NOTICE OF ADDENDUM

ADDENDUM NO. 1

CONTRACT NO. 6505, Project 53W1033
Mezzanine Construction- Sycamore

April 3, 2013

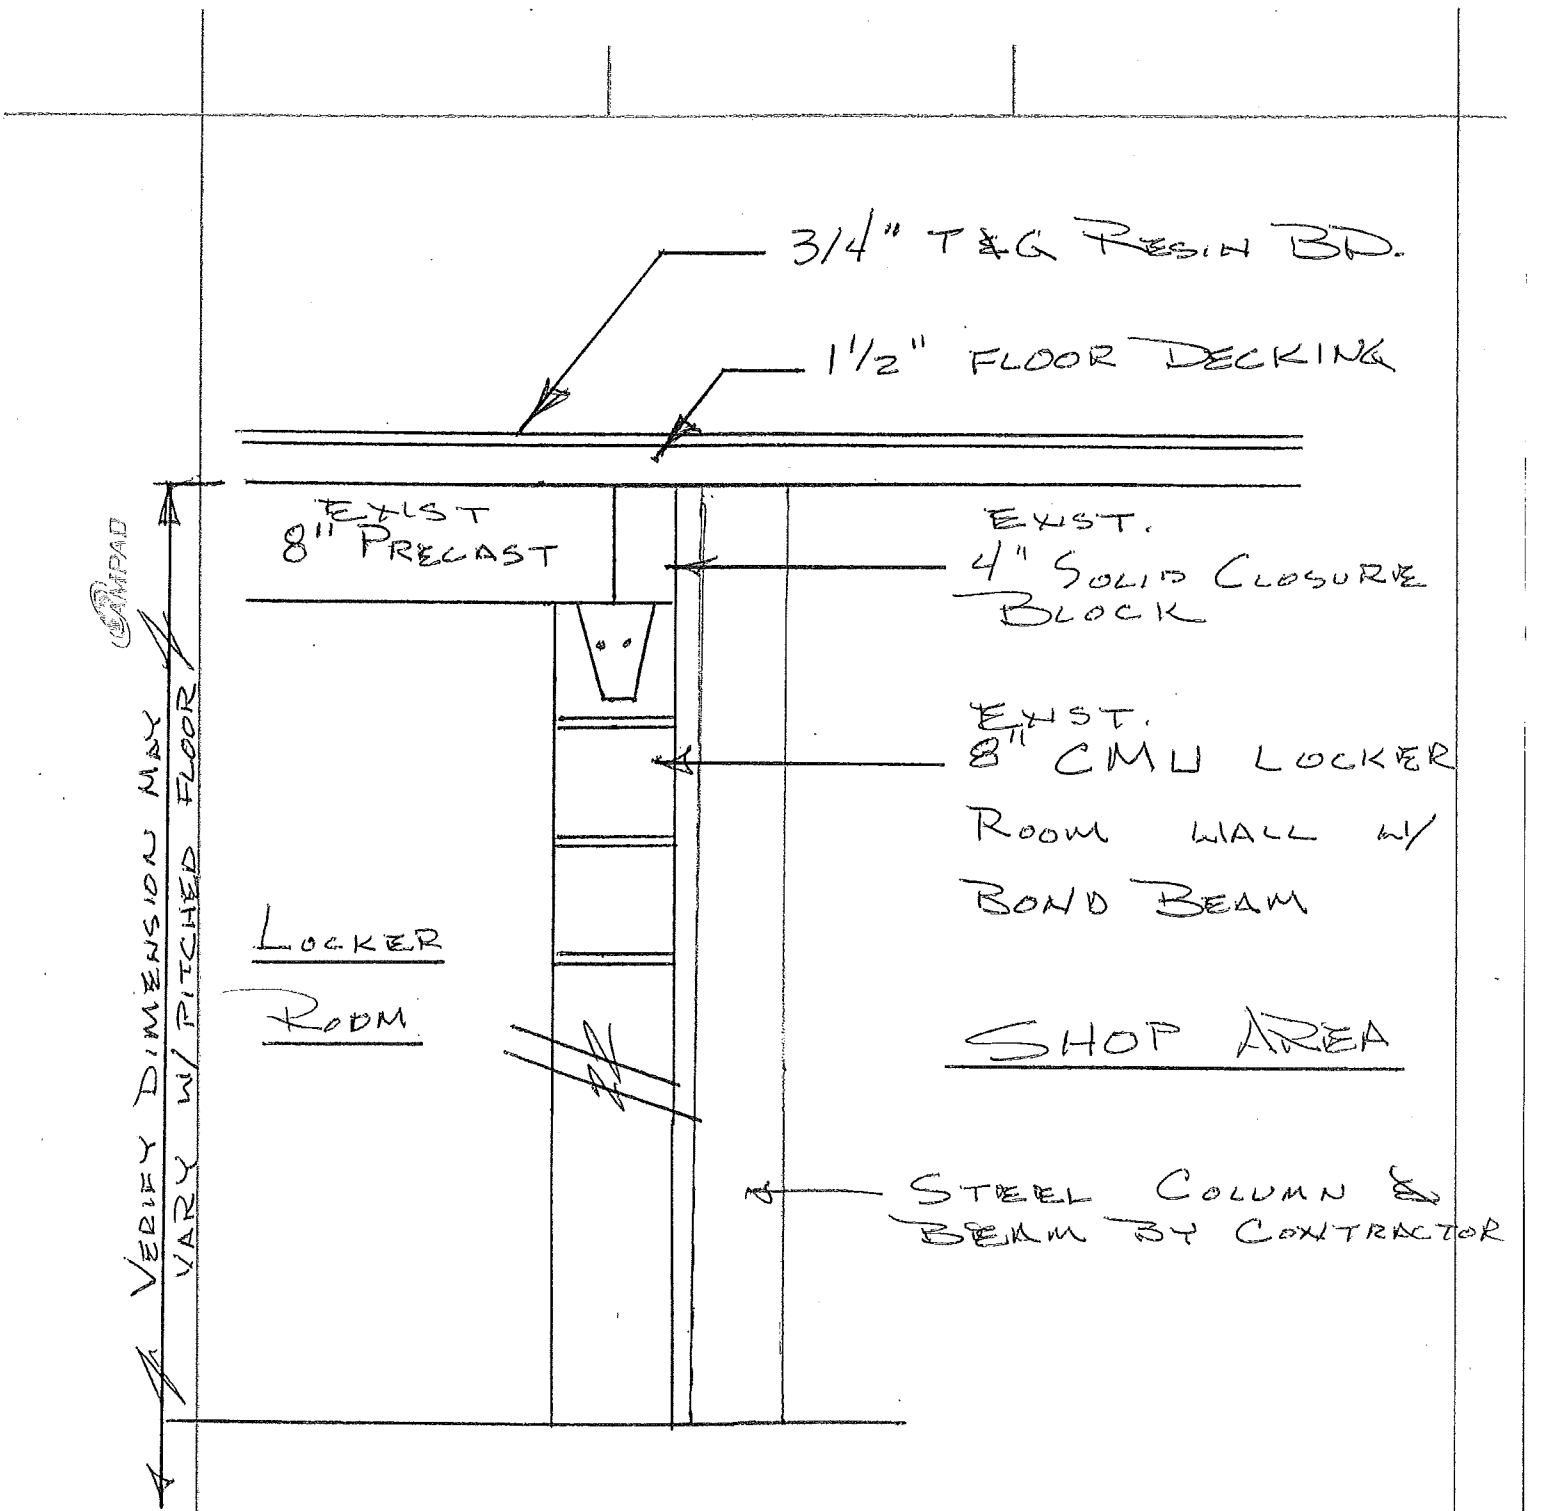
- A. **Sketch 1** is a revised sheet 2 of the plan set. Revisions are as follows:
- The left floor plan corrects the bearing height to match the text on sheet D-5 of the Special Provisions which is correctly stated.
 - The left floor plan now indicates recommended intermediate dimensions for the mezzanine column spacing.
 - The right floor plan corrects the note in the lower left hand corner.
